Errata for FM20L08

Errata Number	002 (Rev AD)
Date	Jan. 24, 2005
Product	1Mbit FRAM, 128Kx8
Product Marking	FM20L08-60 (all package types)

Initial testing has identified some problems with FM20L08 rev AD samples. The new die revision complies with the datasheet FM20L08ds_r0.8.pdf except for the following:

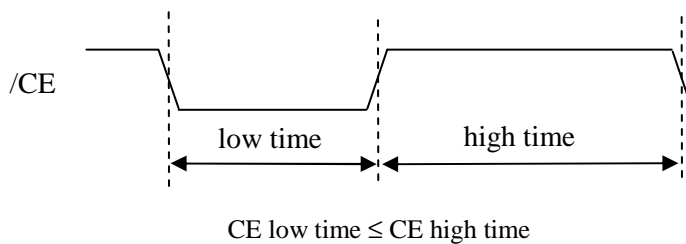
- 1) If the V_{DD} power-up ramp is too slow, the chip will lock out the user. V_{DD} must transition faster than 100 ms from 2.7V to 3.0V. See diagram below.
